Sub: 82वीं संरक्षण समन्वय उप-समिति (पीसीसी) बैठक का कार्यवृत्त/ Minutes of 82nd Protection Coordination Sub-Committee (PCC) Meeting

82nd Protection Coordination Sub-Committee Meeting

Date: 21/08/2025 (Thursday)

C.2 Grid Disturbance in Mynkre area and Leshka HEP of Meghalaya Power System on 1st June'25:

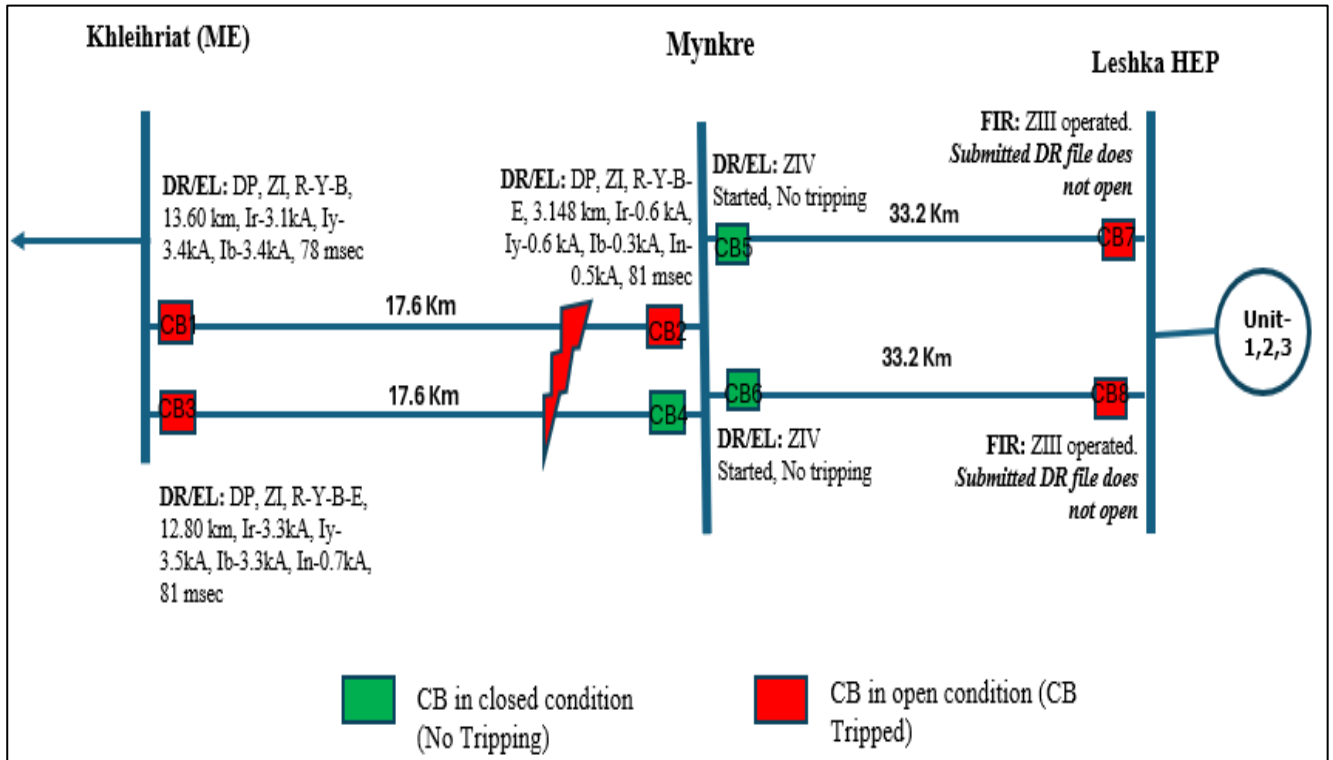
As per DR analysis of 132 kV Mynkre (ME)-Khliehriat(ME) 1 line, solid R-Y-B fault (Ir-3.1 kA, Iy-3.4 kA, Ib-3.4 kA) initiated at 05:37:08.630 Hrs which was cleared within 81 msec on operation of DP, ZI.

C.3 Grid Disturbance in Ningthoukhong area of Manipur Power System on 9th June'25:

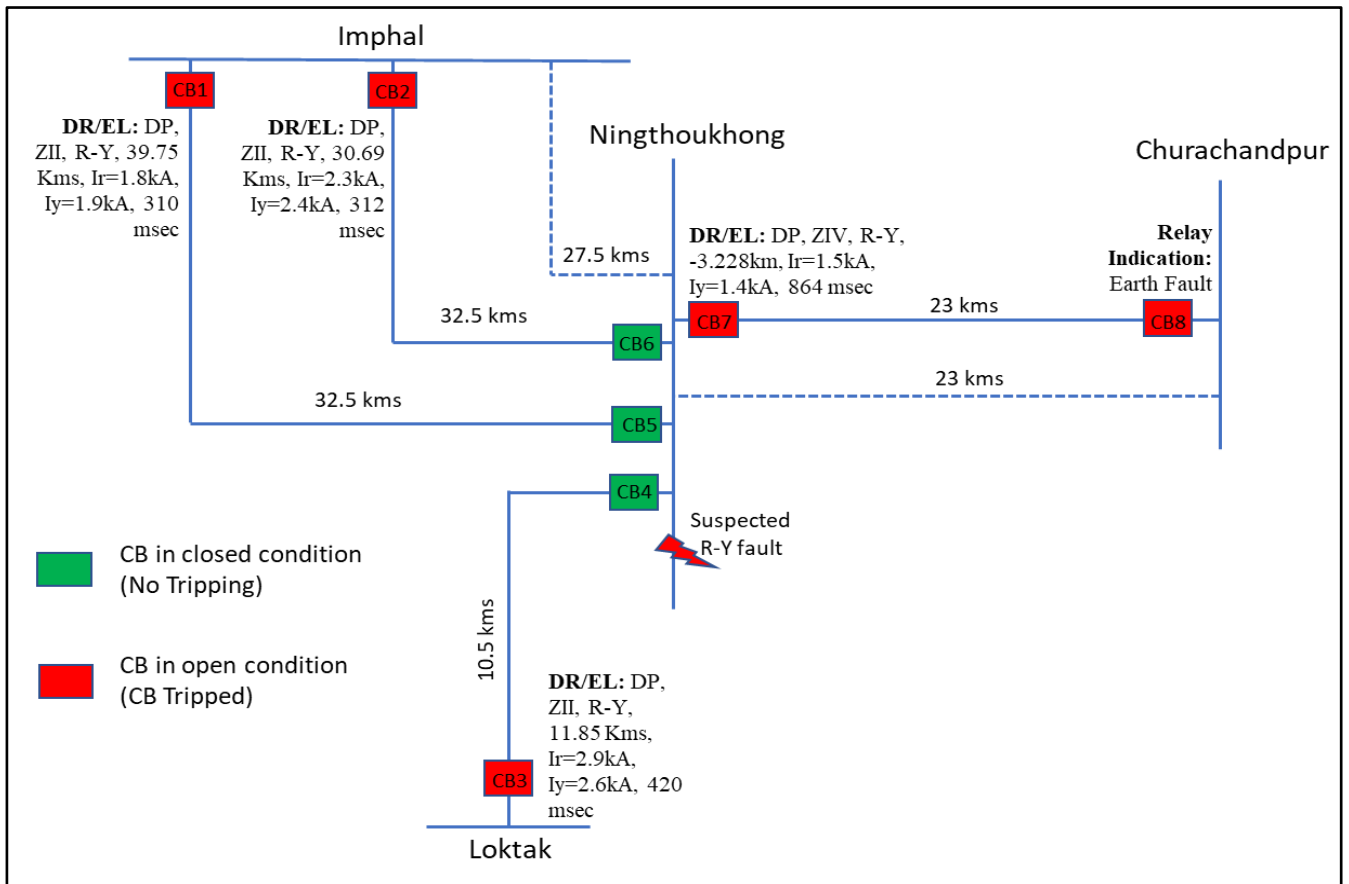
MSPCL to share the root cause of the event and provide update on the above mentioned issues.

C.4 Grid Disturbance in Dharmanagar area of Tripura Power System and Dullavchera area of Assam Power System on 10th June'25:

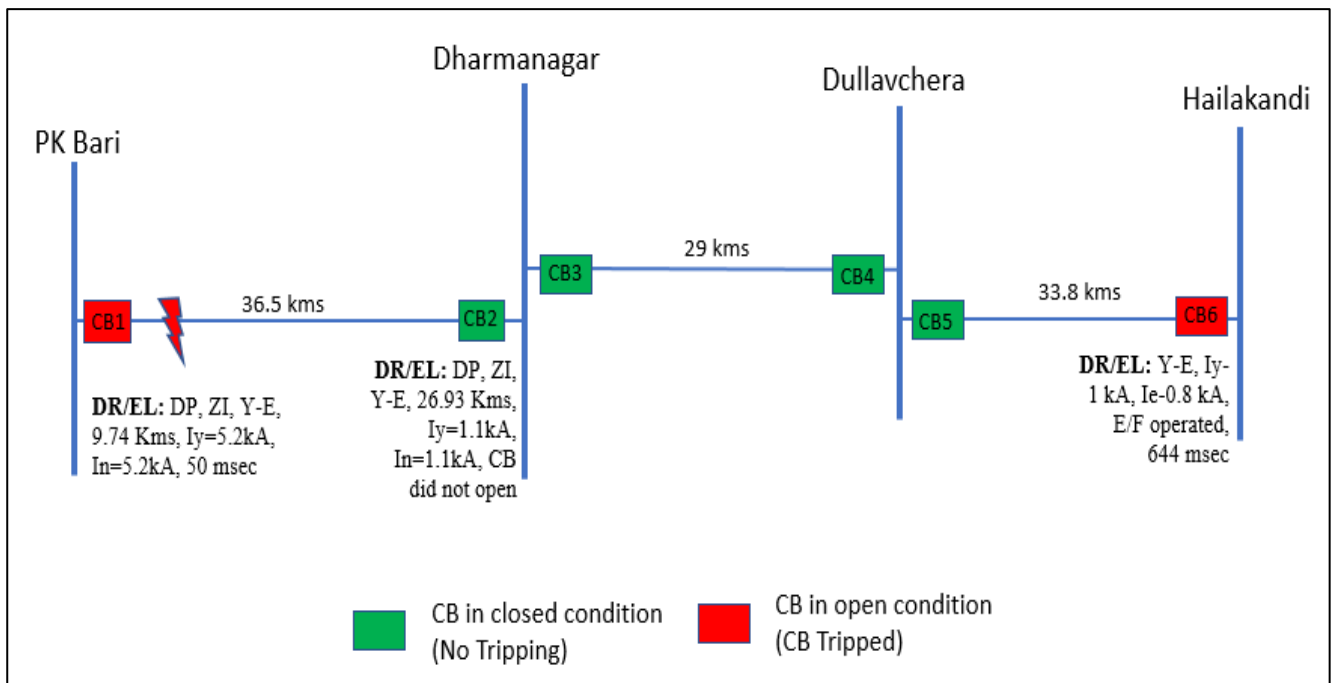
As per DR analysis, Y-N fault (I_b-5.2 kA, I_n-5.2 kA) initiated at 18:40:57.118 Hrs which was cleared within 50 msec from PK Bari on operation of DP, ZI. At Dharmanagar end, ZI trip command issued at 18:25:30.360 Hrs. However, CB did not open at Dharmanagar due to which fault was continuously feeding from Dullavchhera & Hailakandi end. Fault cleared by tripping of healthy 132 kV

Event 1: At 12:26 Hrs of 14.06.2025- Load Loss of 23 MW & Generation Loss of 7.2 MW

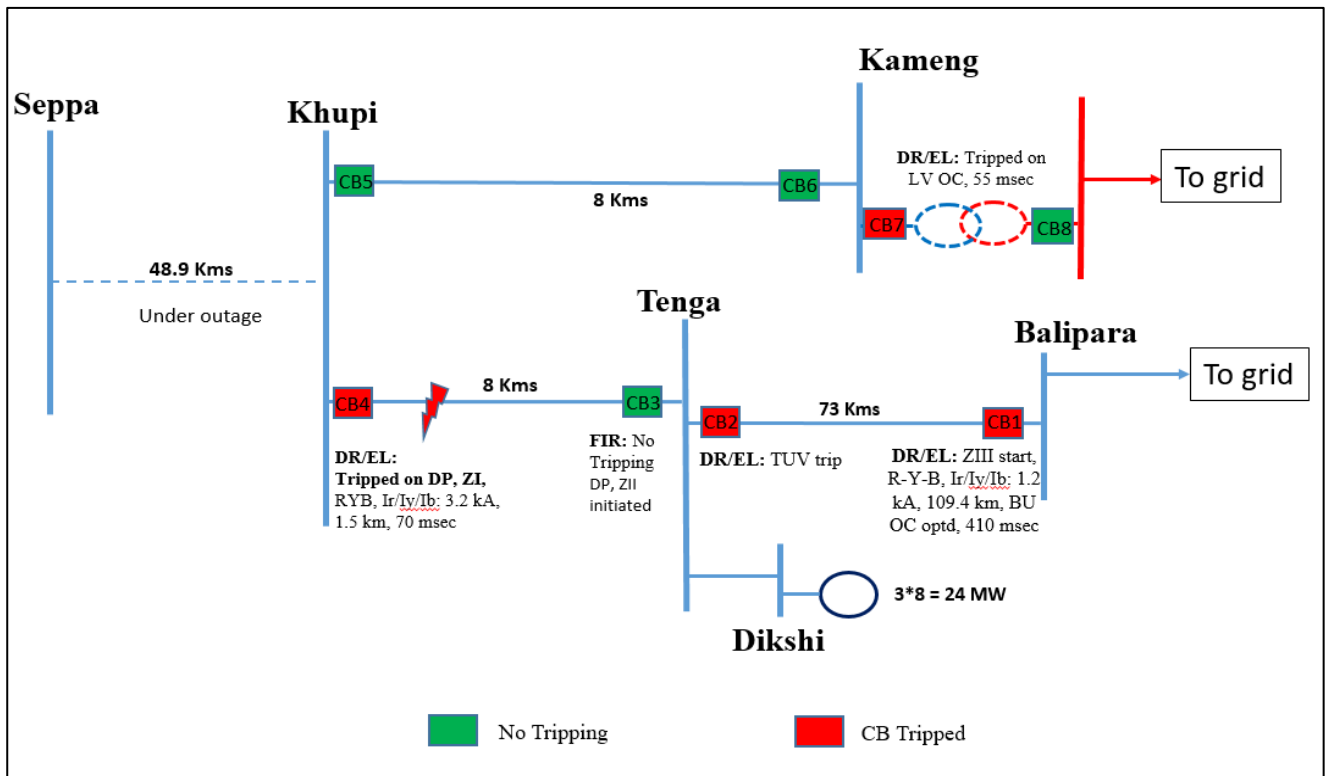
As per available DR & EL data, 3 phase metallic fault initiated in the 132 kV Khupi – Tenga line cleared from Khupi end in DP, ZI, RYB, Ir/Iy/Ib: 3.2 kA, 1.5 km in 70 msecs. Tenga end located the fault in ZII (as per FIR).

Event 1: Regarding tripping at Balipara end, Forum asked DoP Ar. Pradesh to revise the OC and EF settings to follow the NERPC protection settings protocol. Regarding unwanted tripping of Kameng ICT, NEEPCO informed that LV side pickup for DT OC revised to 4620 A. Regarding non-operation of protection at Tenga end, forum noted that ZII did not operate as fault was cleared from Balipara end aggressively.

Event 2: At 10:28 Hrs of 23.06.2025- Load loss of 34 MW & generation loss of 10 MW

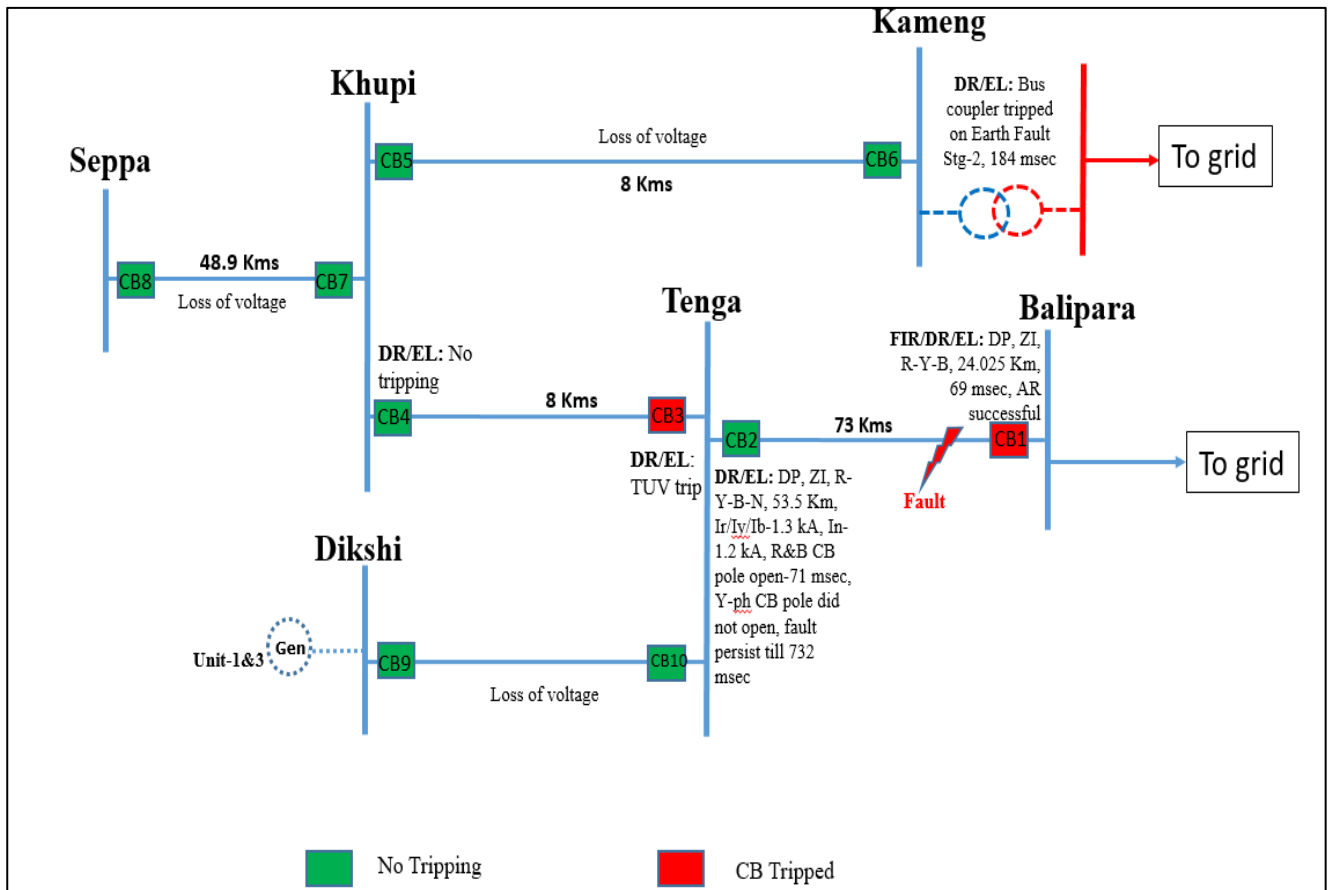
As per DR analysis, solid R-Y-B-N fault occurred in 132 kV Balipara-Tenga Line at distance of 53.5 Km from Tenga end which was cleared within 69 msec from Balipara end on operation of DP, ZI (AR successful). ZI trip command issued from Tenga end and R & B-phase CB pole opened after 71 msec. However, Y-ph CB pole did not open and fault current persisted till 732 msec.

Event 1:

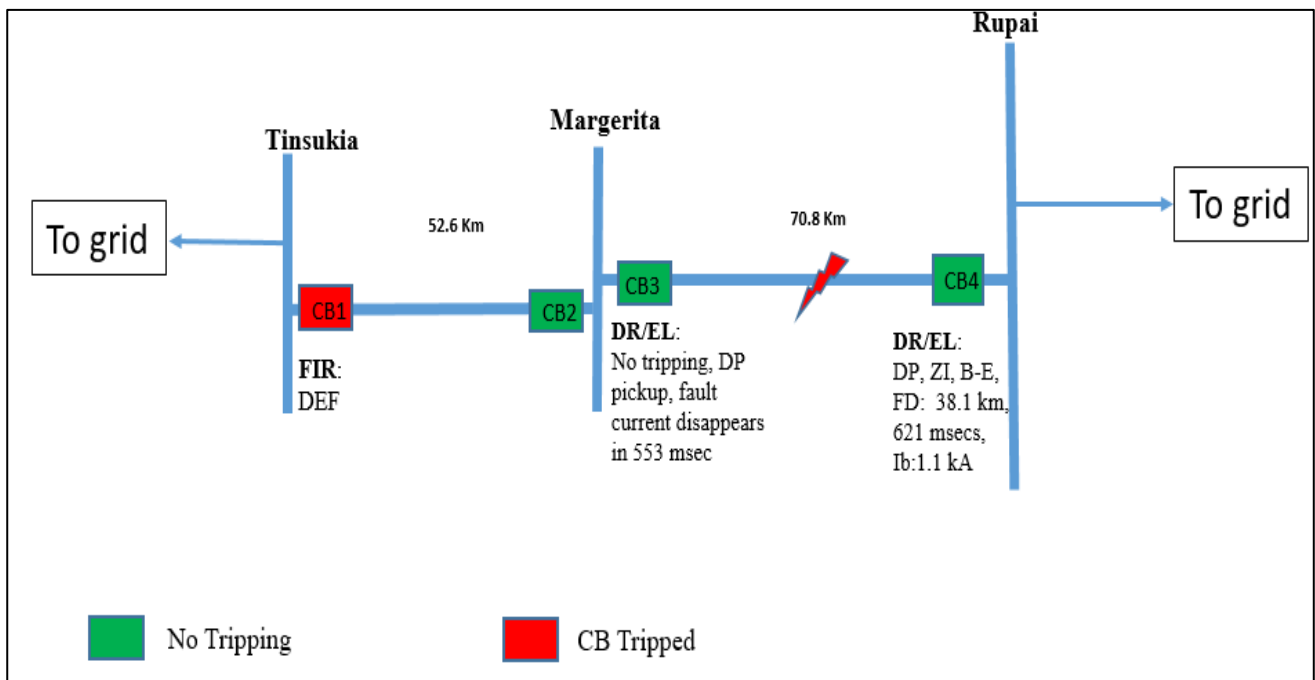
As per DR analysis, at 10:50:26.946 Hrs, high resistive B-E fault (Ib-1.1 kA, Vbe-51 kV) appears in 132 kV Rupai-Margherita line at a distance of 38.1 Km which was cleared from Rupai end within 621 msec on operation of DP, ZI. No tripping observed at Margherita end (DP pickup, fault current disappears within 553 msec).

Event 2:

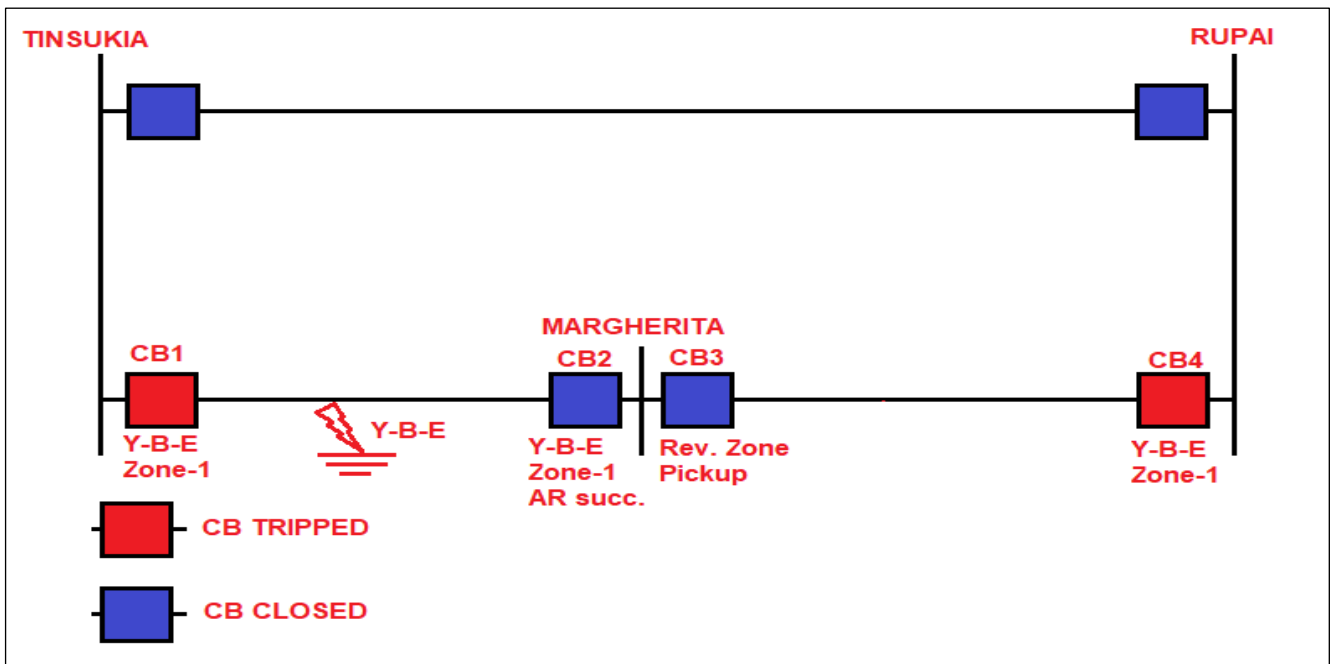
As per DR analysis, Y-B-E fault in 132 kV Tinsukia – Margherita line cleared from Tinsukia and Margherita end in 90 msec on operation of DP, ZI. Margherita end (CB2) successfully auto-reclosed.

Event 2: Forum noted that zone 1 at Rupai for 132 kV Margherita line is overreaching and requested AEGCL to revise the reach of Zone1 protection. AEGCL informed S/D will be taken for tesing of relay.

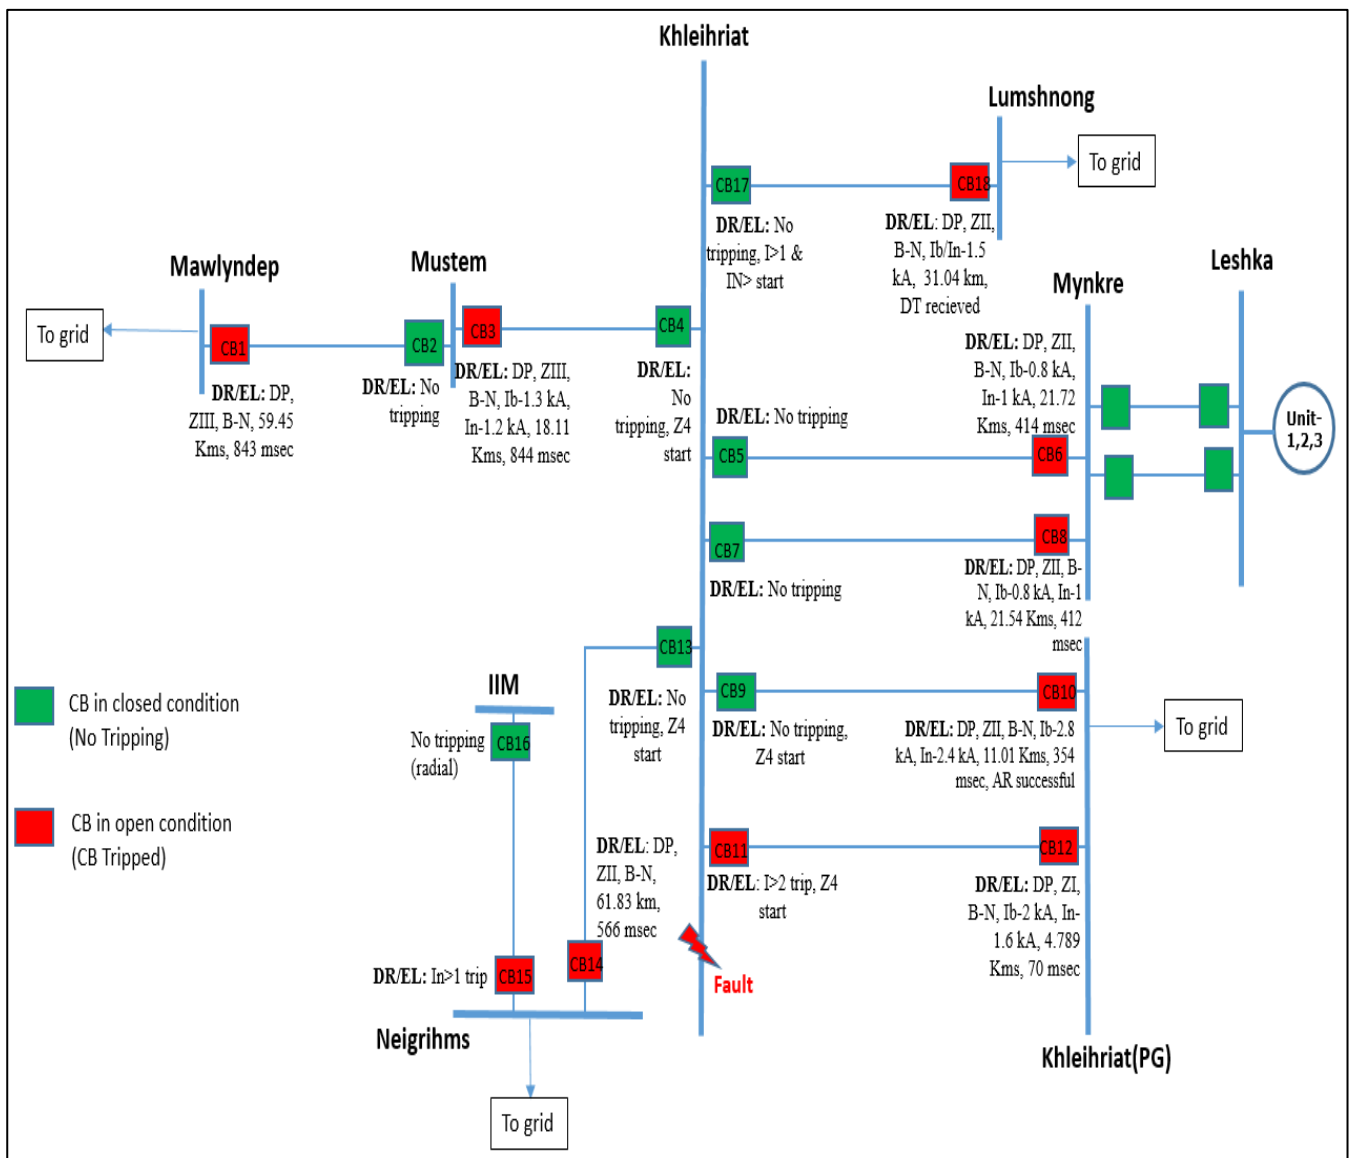
- Tripping of 132 kV Mustem-Khleihriat line on Z3 from Mustem end is inferred unwanted. Z3 reach setting needs to be reviewed and revised as per NER protection philosophy.

2	132 kV Khleihriat-Khleihriat(PG) II line tripped on I>2 from Khl(ME) end	Highset O/C setting to be disabled at Khl(ME)
3	AR operated successfully at Khleihriat(PG) end for 132 kV Khleihriat-Khleihriat(PG) I Line	AR successful due to incorrect mapping which has been rectified.
4	Tripping of 132 kV Mustem-Khleihriat line on Z3 from Mustem end	LFL of the feeder was carried out to ascertain the exact line length and line length indicated was 16.9 Km. Earlier setting was kept as per 12.69 Km. The setting of 132 kV Mustem-Khleihriat line has been revised as per new line length of 16.9 Km on 25th June'25.
5	DT received at Lumshnong end for 132 kV Khleihriat Line	To be checked by MePTCL
6	Tripping of 132 kV Neigrihms-IIM line on E/F from Neigrihms end for fault in reverse direction is unwanted	Rectified
7	Tripping of Umiam Stg-II Unit-2 for fault in 132 kV Khleihriat Bus	GT O/C protection operated. To be checked by MePGCL

C.8 Multiple tripping in Ningthoukhong S/S of Manipur power system on 20th June'25:

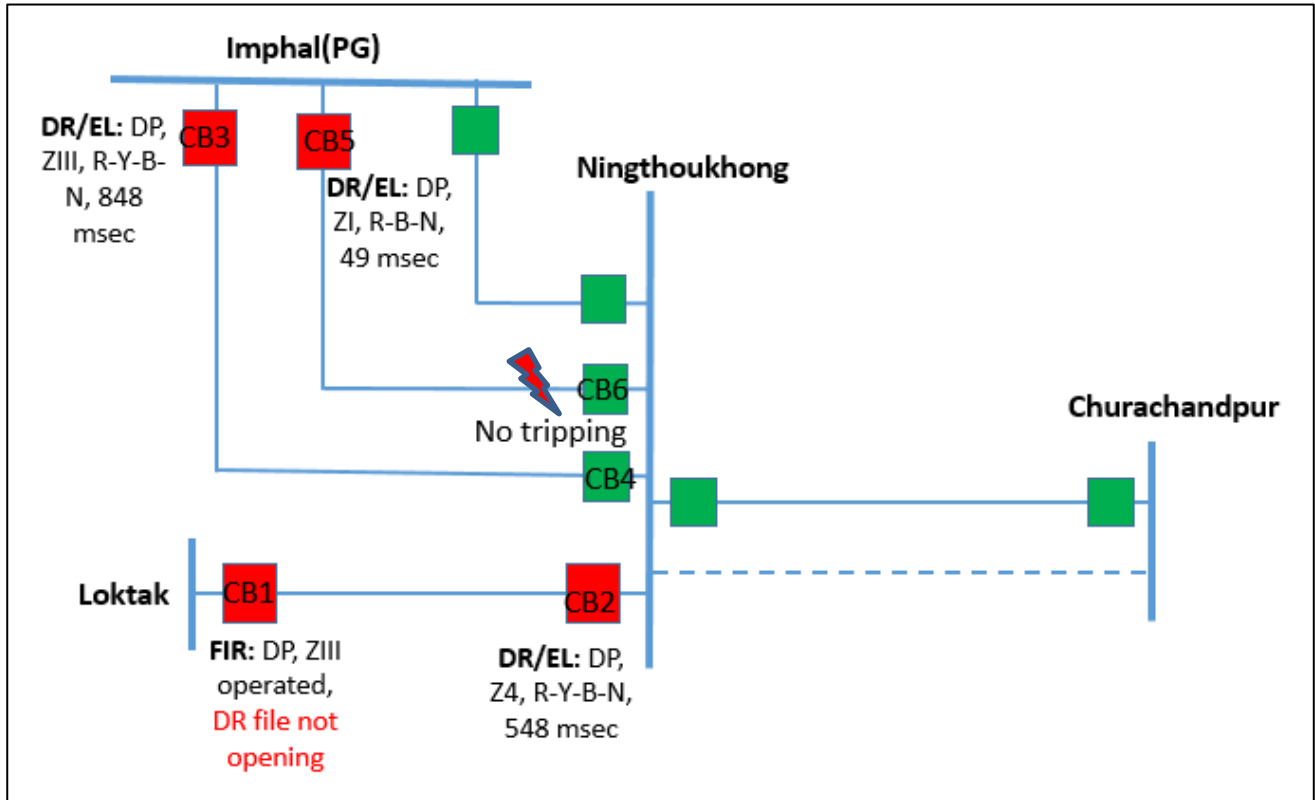
As per DR analysis, solid R-B-N fault (I_r -2.4 kA, I_b -0.8 kA, I_n -1.7 kA) initiated at 03:52:00.925 Hrs which was cleared within 49 msec from Imphal(PG) end on operation of DP, ZI. There was no tripping from Ningthoukhong due to which fault was continuously feeding from other lines at Ningthoukhong.
